Limerick Generating Station, Units 1 and 2
Facility Operating License Nos. NPF-39 and NPF-85
NRC Docket Nos. 50-352 and 50-353

Subject: First Six-Month Status Report in Response to March 12, 2012 Commission Order Modifying Licenses with Regard to Requirements for Mitigation Strategies for Beyond-Design-Basis External Events (Order Number EA-12-049)

**First Six-Month Status Report for the Implementation of Order EA-12-049, Order
Modifying Licenses with Regard to Requirements for Mitigation Strategies for Beyond-
Design-Basis External Events**

Attachment 1a

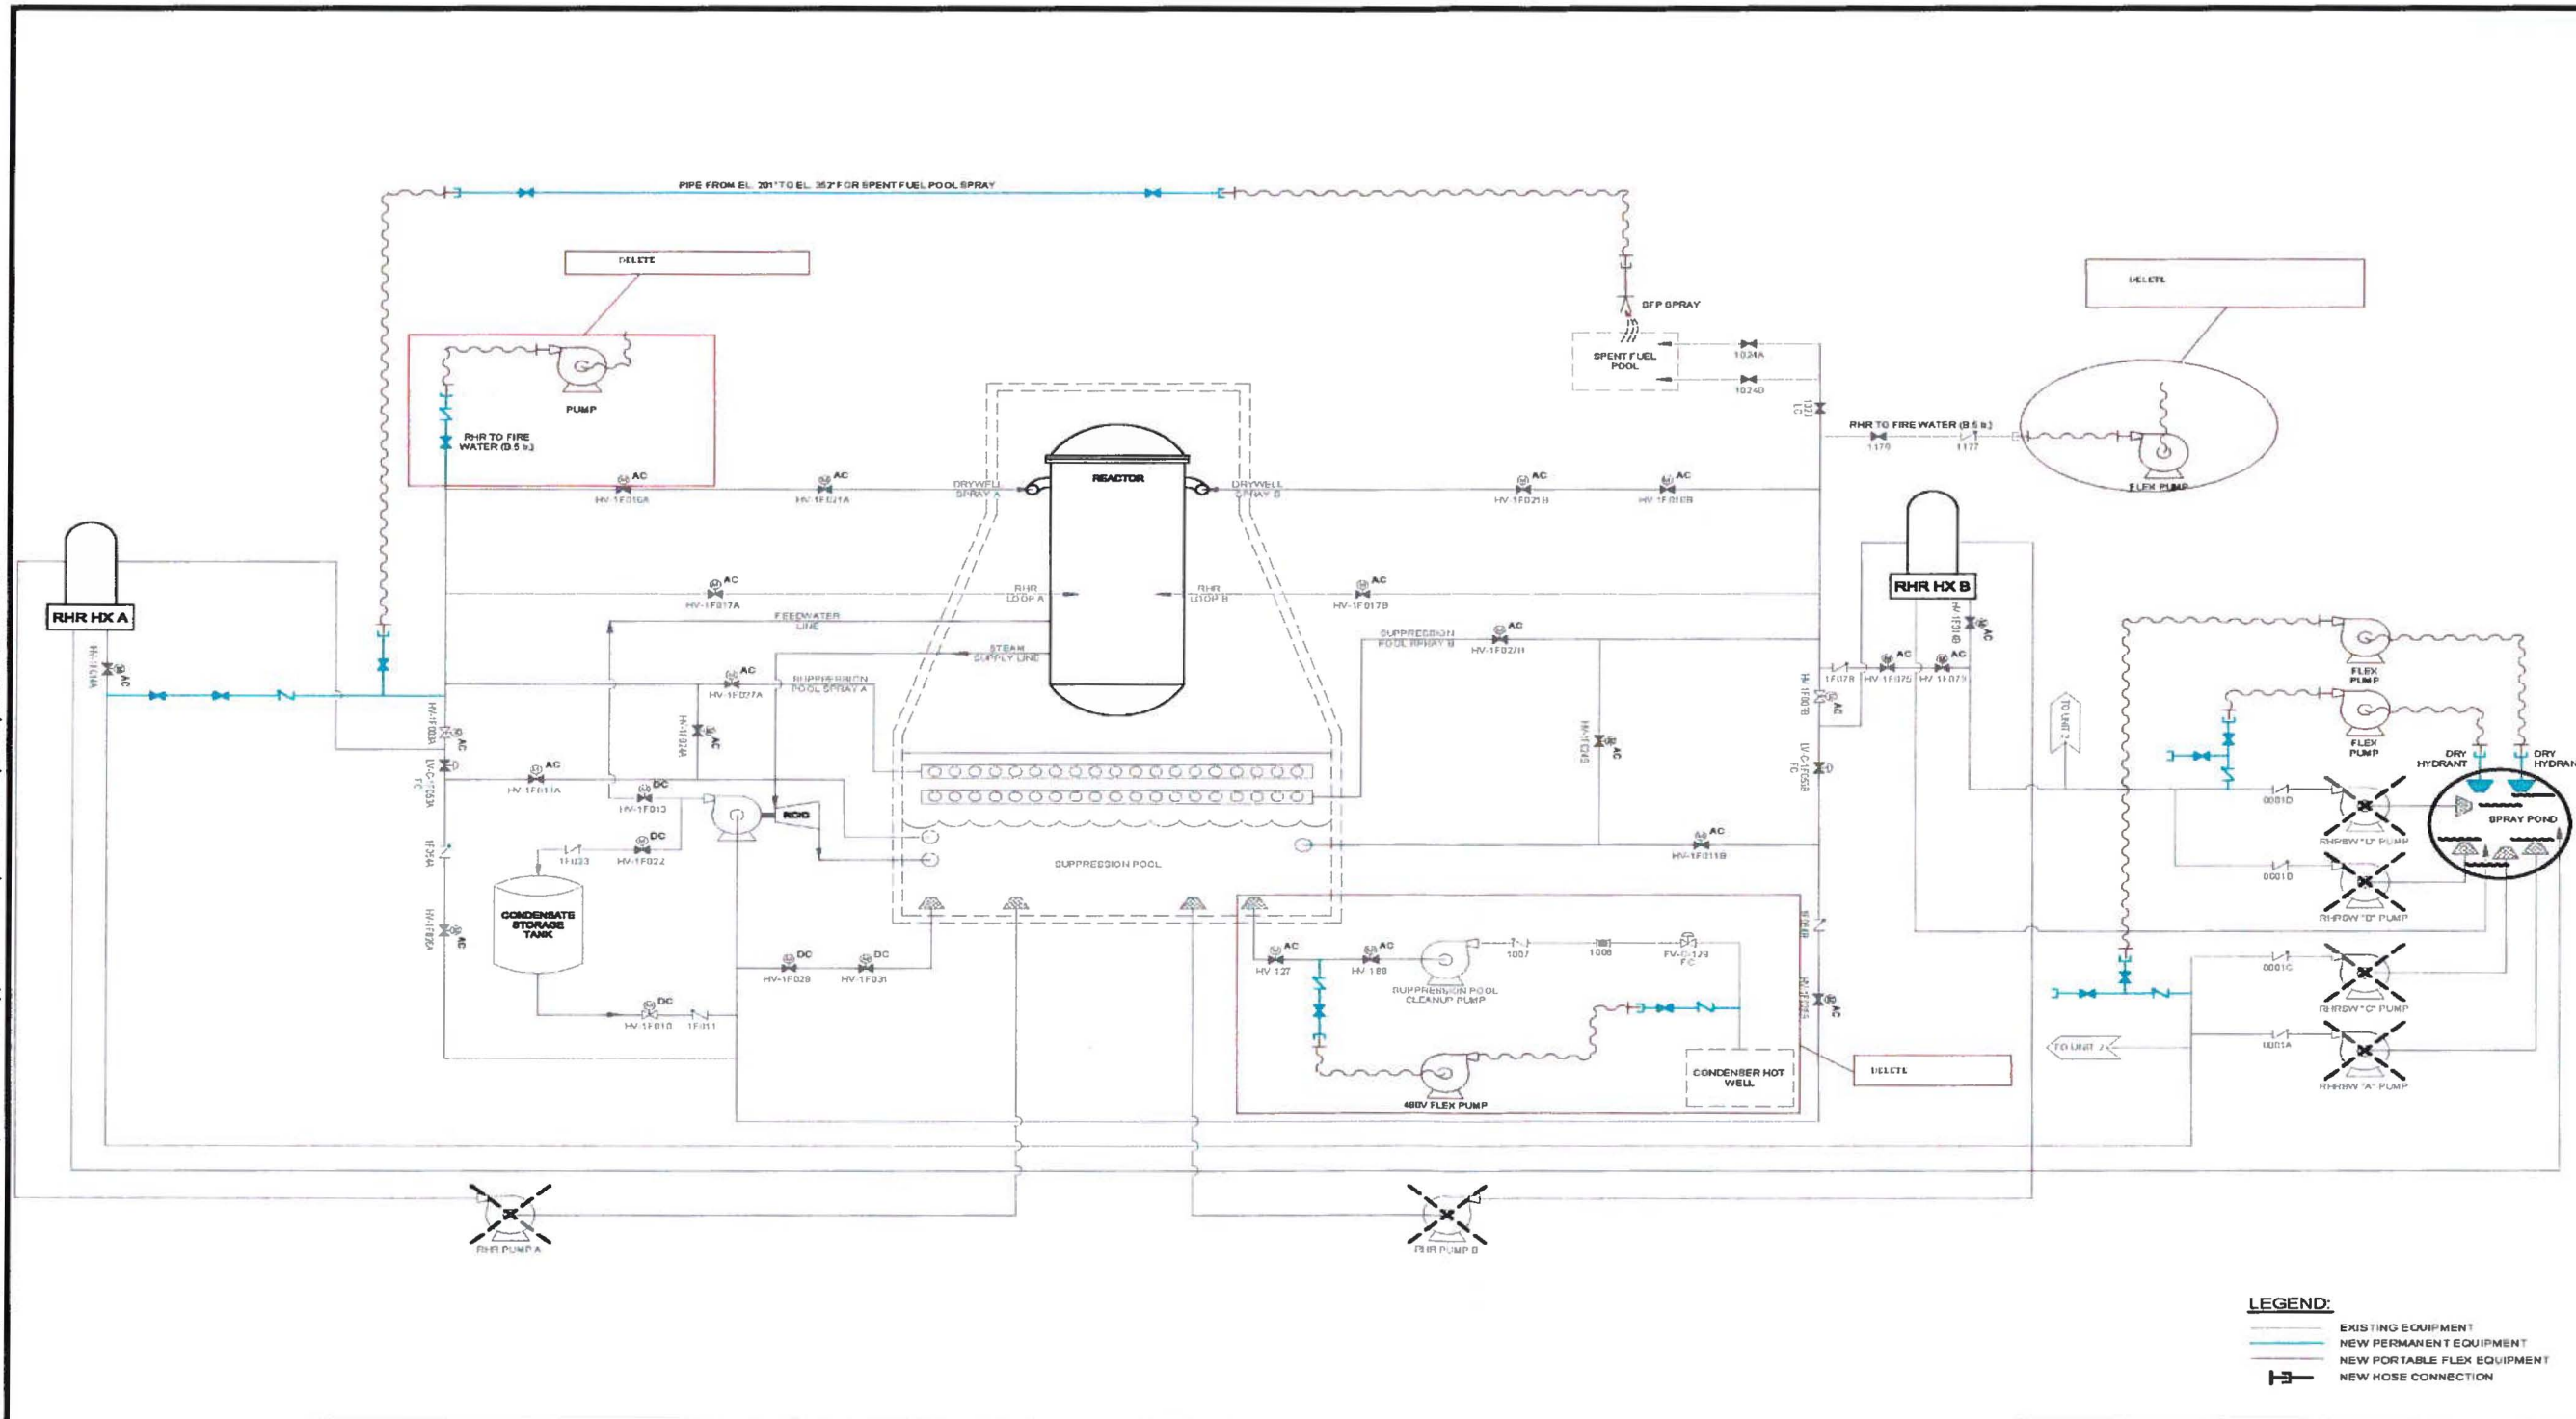
Attachment 3 of Reference 1 contained conceptual sketches of the water supply and electrical power supply strategies. On the mechanical sketch, a FLEX pump is shown supplying water to the RHR to Fire Water Connection (B.5.b). This was not described in the body of the integrated plan since this was an initial conceptual design that was evaluated and determined to not be the optimal alternate strategy. In addition, a FLEX pump is shown bypassing the existing Suppression Pool Cleanup pump. This was also not described in the body of the integrated plan since this was an initial conceptual design that was evaluated and determined to not be an optimal strategy. These changes are shown in Attachment 1a (Unit 1) and Attachment 1b (Unit 2).

Attachment 1c

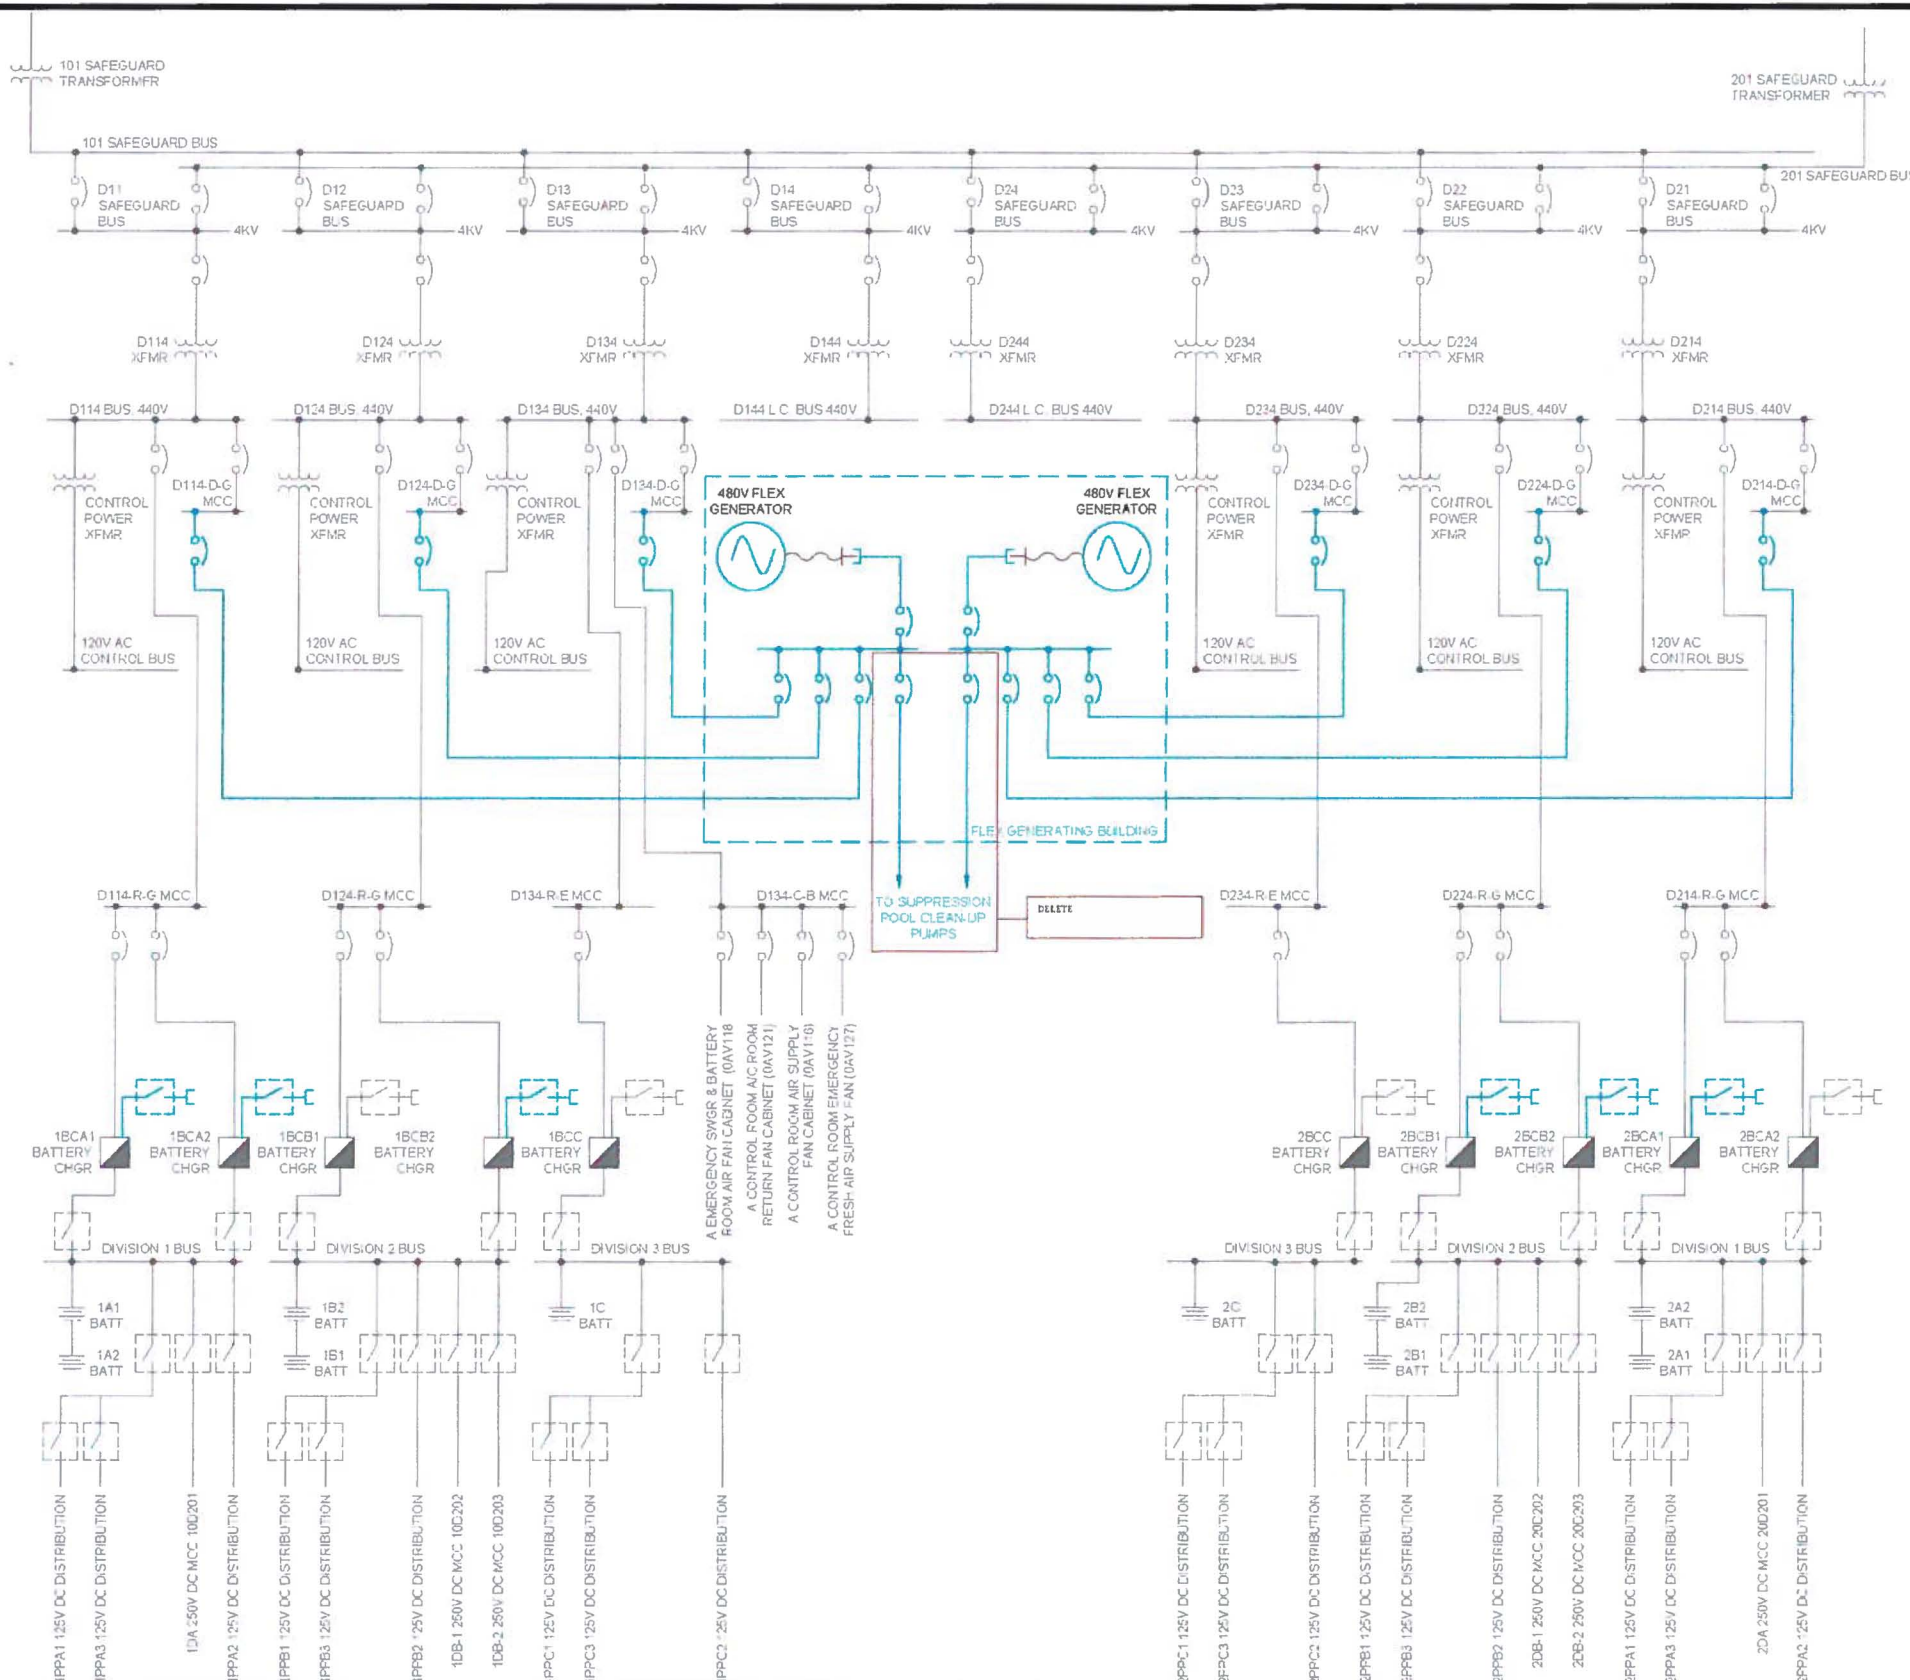
On the electrical sketch, a power supply from the FLEX Generators was shown to the suppression pool cleanup pumps. This was not described in the body of the integrated plan since this was an initial conceptual design that was evaluated and determined to not be an optimal strategy. These changes are shown in Attachment 1c.
